REPORT OUTLINE FOR AREA PLANNING COMMITTEES**Report No.**

| Application Number | PL/2022/03760 |
| Site Address | Former Wiltshire College, Cocklebury Road, Chippenham, Wiltshire, SN15 3QD |
| Proposal | Erection of Retirement Apartments (Category II Type) with Communal Facilities and Car Parking & Erection of Assisted Living Accommodation (Class C2) with Communal Facilities And Car Parking |

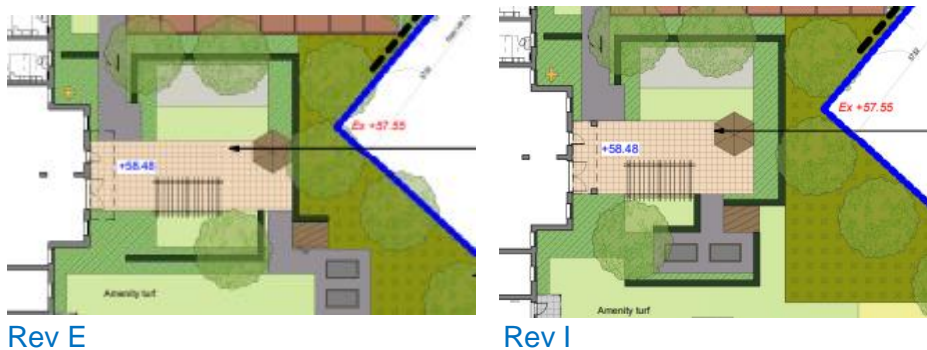
Design matters raised in my consultation response dated 23.12.2021 on ENQ/ 2021/0442 satisfactorily addressed:

Re specific detail within point 1: The proposed design in its scale (massing and height) and built form is essentially as that proposed on the sketch elevations to ENQ /2021/04420. These drawings have been firmed up with modelling of the façade adjusted to now show an appreciably regular and balanced setting out and proportioning between general wall face and contrast wall 'panels' between certain window openings, from the discordant irregular appearance of panels previously shown and the prominent projecting utilitarian balconies on steel legs previously shown awkwardly fronting Cocklebury Road and Sadlers Mead street corner have been appropriately deleted (but see point 4 below) and similarly balconies on their return elevations and on prominent return elevations set back within the site are now shown framed in masonry surrounds.

Re point 3: From reviewing the firmed up drawings now submitted including the Footprint Comparison (Design & Access Statement page 42 and Context Elevations I consider the subject proposed building wing of the Retirement Living building would not be any more dominant than the wing of the planning approved 17/05828/FUL in their respective proximity to the neighbouring existing bungalows on Sadlers [20.10.2022 Revised Plans Aug 2022](#) 16.06.2022 Urban Design consultation response – PL/2022/03760
